## Brooks Park Harwich, MA

## Town of Harwich ADA Transition Plan

July 2018

### Brooks Park, Harwich, MA Renovation 2017 (Ongoing)

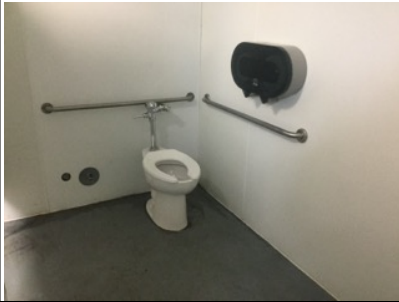
<b>Access to Goods and Services</b>										
<b>Doors, Doorways, &amp; Gates</b>										
15	Baseball	Ext.		Doors, Doorways, & Gates	Other		Maneuvering clearance(s) not provided 10" solid surface not provided	- -	Provide a 48" min. maneuvering clearance at at the gate. Swinging door and gate surfaces within 10 inches of the finish floor or ground measured vertically shall have a smooth surface on the push side extending the full width of the gate.	1
